R66 SERVICE BULLETIN SB-21

SUBJECT: Oil Tank Outlet Modification

ROTORCRAFT AFFECTED: R66 Helicopters S/N 0003 thru 0268. Spare G689-1 revision H and prior oil tank assemblies are also affected.

FIGURE 1

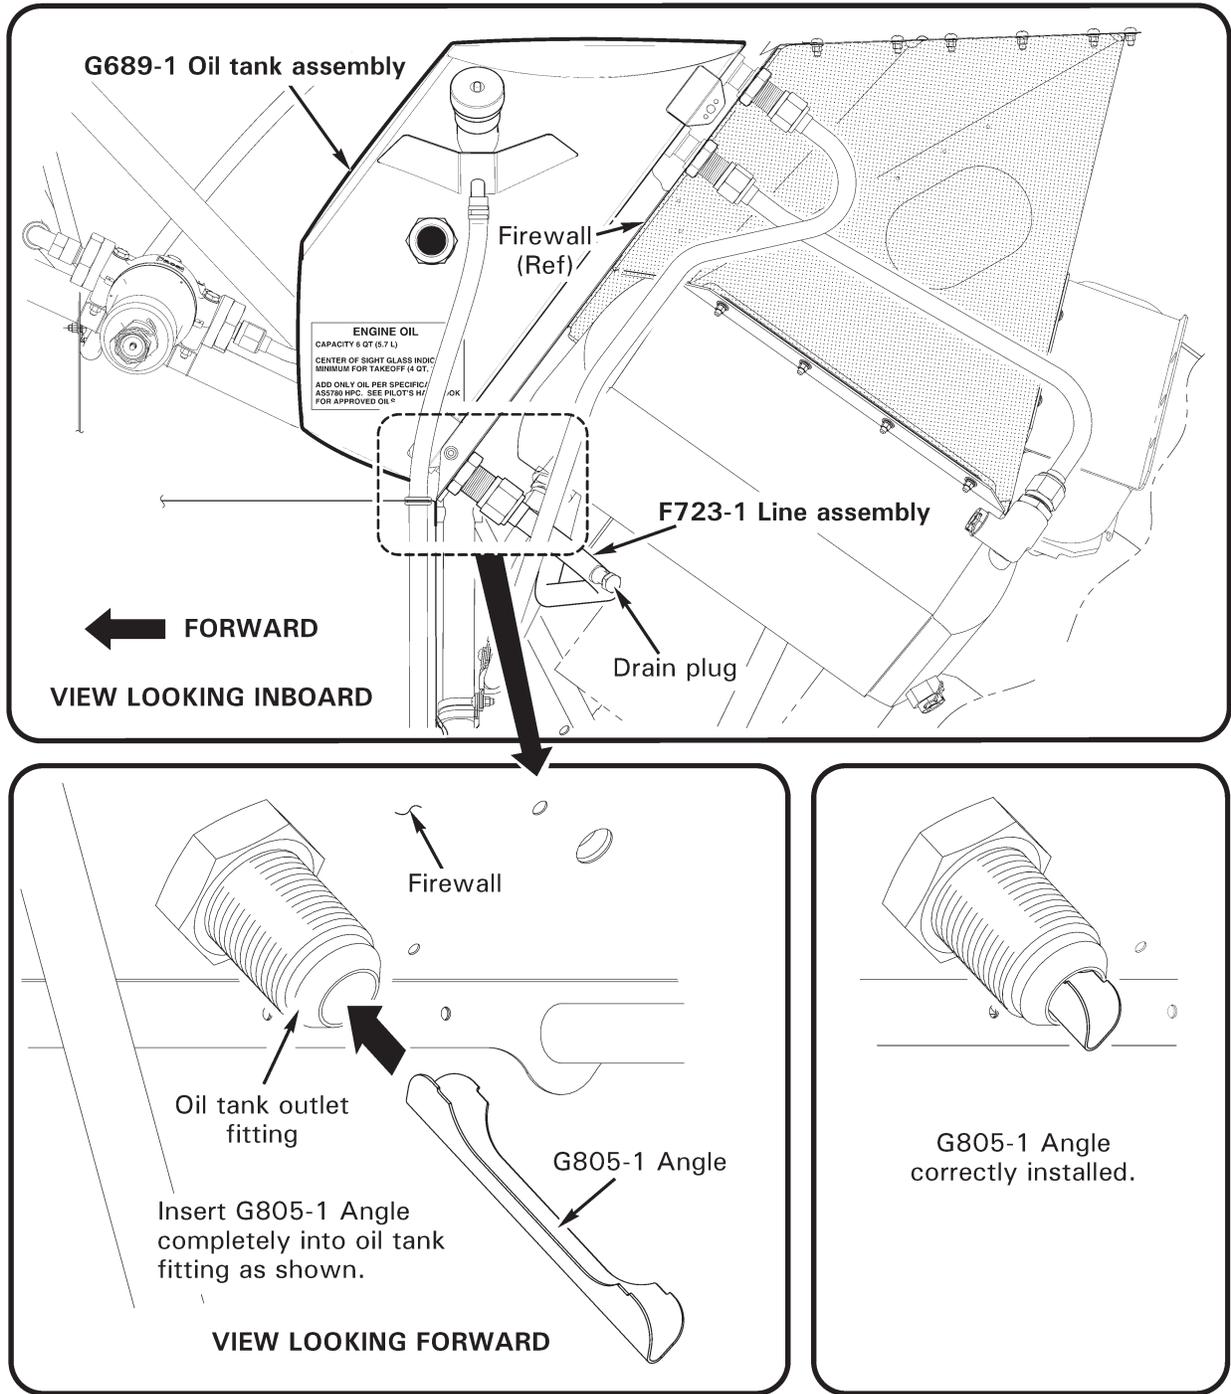
BACKGROUND: RHC has received a report of an oil tank internal baffle breaking loose and blocking the tank outlet. G689-1 revision H and prior oil tank assemblies were manufactured using a heat treat process which may have cracked the baffle welds. This bulletin requires installing an angle in the tank outlet that would prevent a failed baffle from blocking the outlet.

2. Drain engine oil per R66 Maintenance Manual (MM) § 12-60, utilizing suitable clean container if reusing oil.
3. Refer to Figure 1. Disconnect F723-1 line assembly from tank fitting at firewall.

4. Insert G805-1 angle (orientation optional) in oil tank outlet fitting until angle snaps in place. Pinch flanges of angle minimum required to enable insertion.

5. Connect F723-1 line assembly to tank fitting. Special torque nut to 675 in.-lb. Torque stripe fitting per MM Figure 5-1.
6. Add engine oil per MM § 12-60.
